Catfield Fen. Changes in Land Management 1970-2012

Catfield Fen: Hydrological Investigation and Reasons for Fen Drying out

AWS Comments on Catfield Fen Final Report

Catfield Fen Investigation, Final Report 5 April 2012

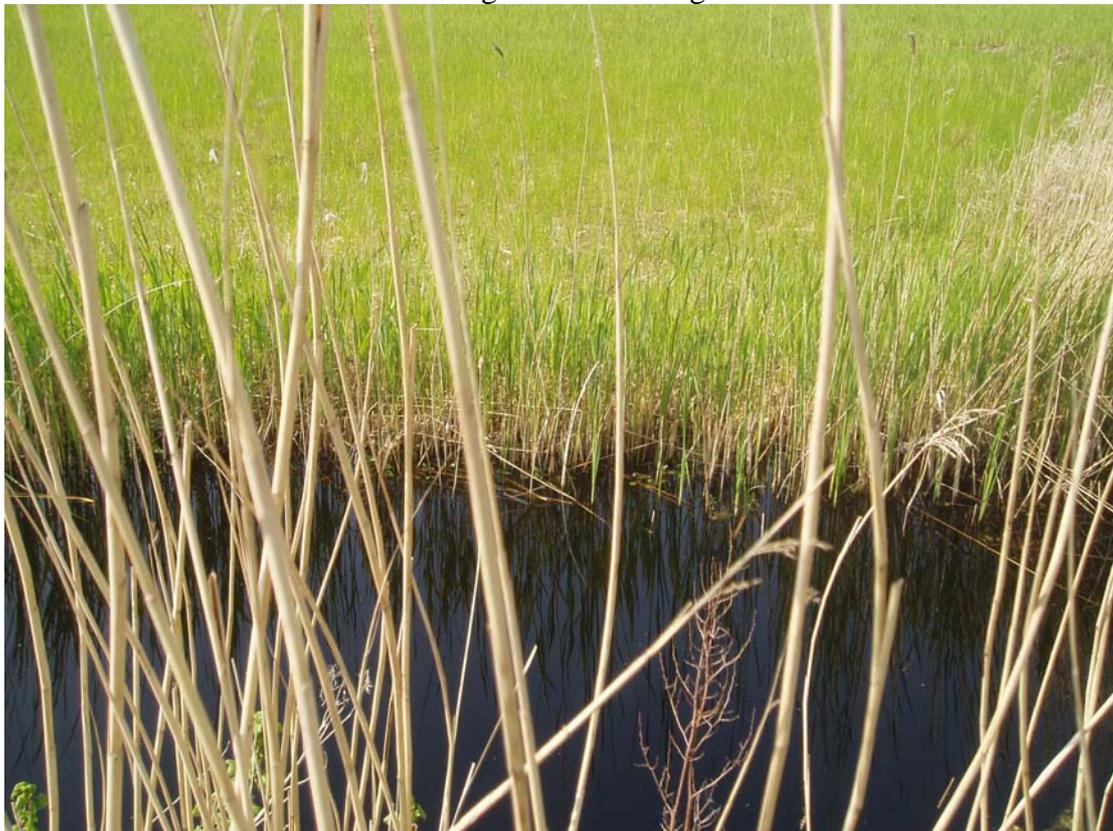
2. Terrestrialisation is occurring at Catfield Fen. The attached pictures show raised marshes at maximum water level on Middle Marsh. The pictures were taken on 22nd May 2012 with the water level at the over topping level (maximum water level- see picture 1 showing water level at around 6.4 at the gauging board near the Mill TG32/71). The marsh is 18 inches above the maximum water level.

Picture 1- water level at maximum level on 22nd May 2012 at TG32/71

Picture 2: Middle Marsh and adjacent Mill marsh are 18inches higher than maximum water level on 22nd May 2012, also note well mowed grass access margin

Picture 3. Another view of Middle Marsh showing how high it is from the top of the water

Picture 4 shows a good reedbed where water can freely access the surface, which is vital for good reed growth. Note the water level is slightly higher than the marsh top. Also note that the previous crop has been removed and terrestrialisation has not occurred. The ditches are clear of vegetation allowing free movement of water.
